**Re: Third Submission Framework Development Plan, Site Plan and Plat Review – 470
Storage-FDP, CSP, and Plat**

Application Number: **DA-2115-00**

Case Number(s): **2017-6054-00**

Third Submission Framework Development Plan, Site Plan and Plat Review

5A. EXISTING FRAMEWORK DEVELOPMENT PLAN -PIONEER BUSINESS PARK

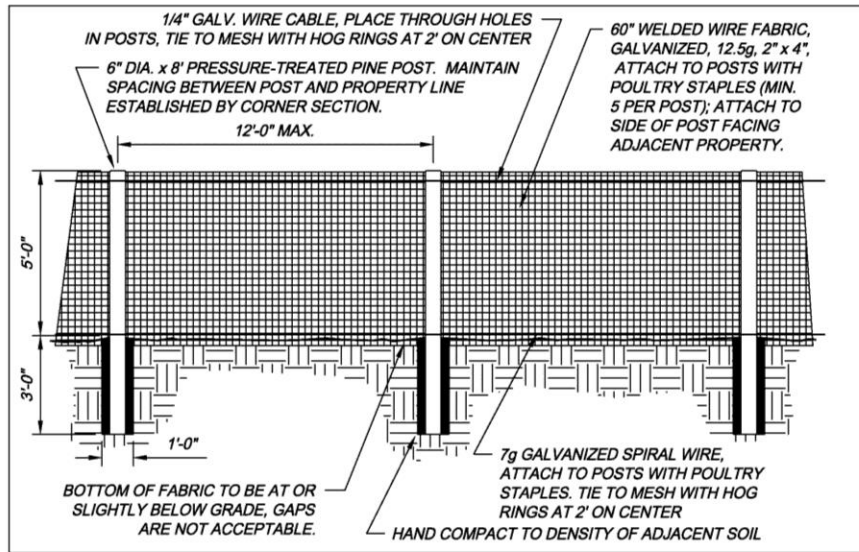
An FDP was approved in 2007 for the four parcels abutting South Rome Way known as Pioneer Business Park. The FDP set standards for landscaping and fencing along the boundary with the Plains Conservation Center. Amend FDP and CSP documents consistent with the Pioneer Business Park FDP criteria relative to landscaping, fencing, and special landscape buffer.

**PLAINS CONSERVATION
CENTER (PCC) FENCE**

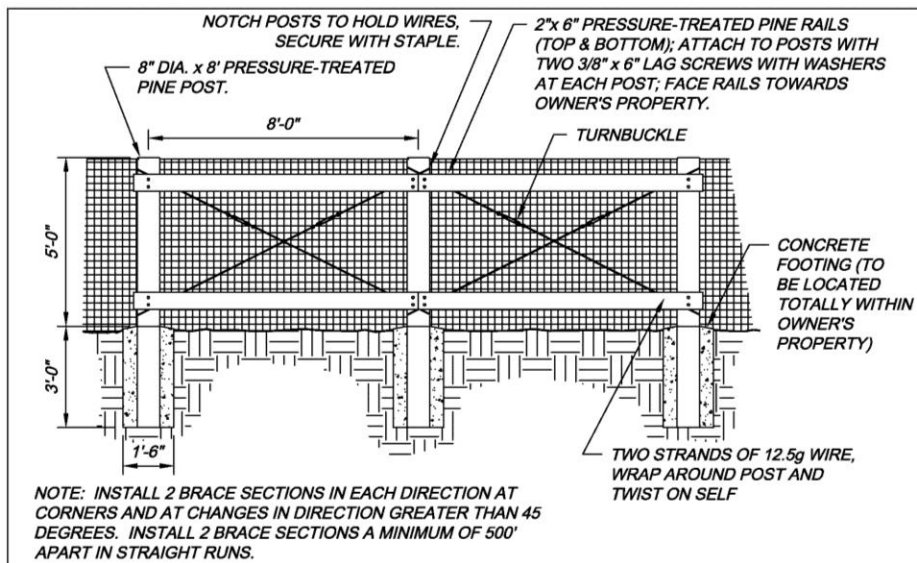
The standard PCC fence, a 5-foot high galvanized wire fabric fence mounted to 6-inch diameter wooden posts, shall be required along the common boundary with the PCC. The fence shall be installed along the inner edge (private property side) of the Special Landscape Buffer. See standard details provided below.
